**KANE PACKAGE PHILIPPINE INC.**

INVESTIGATION REPORT FORM (IRF)

Customer	BROTHER INDUSTRIES PHILIPPINES, INC.	Attention To	REXEL ALMARIO
Item Code	D037LJ001	Department	PRODUCTION
Item Description	CARTON DCP-J4250N JPN	Date of Detection	250710
Job Order Number	JO-25-IPD-00814-3	Section Detected	QA SCREENING

ILLUSTRATION OF THE PROBLEM**ACTUAL:** Misalign print**REQUIREMENT:** No misalign print

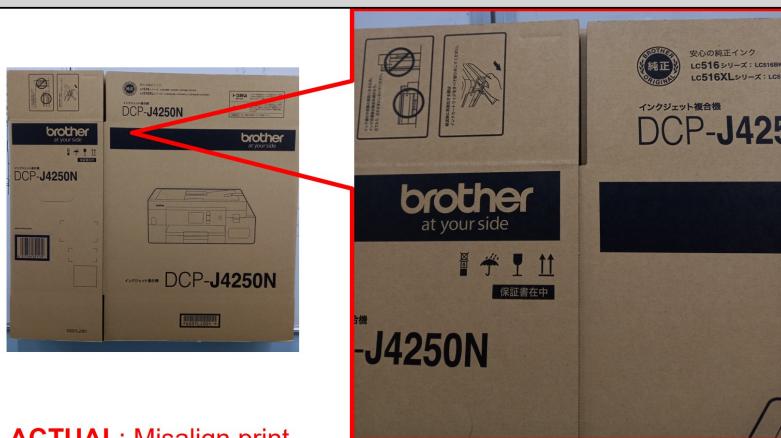
MISALIGN PRINT

+/- 5 printing tolerance

Misalign print is above printing tolerance

WHY 1 : Sheets did not feed consistently into the machine that cause misalign print.

WHY 2 : Encountered random uneven sheets during EQOS printing.

WHY 1: Additional suteban on lateral for visual reference of misalign print.
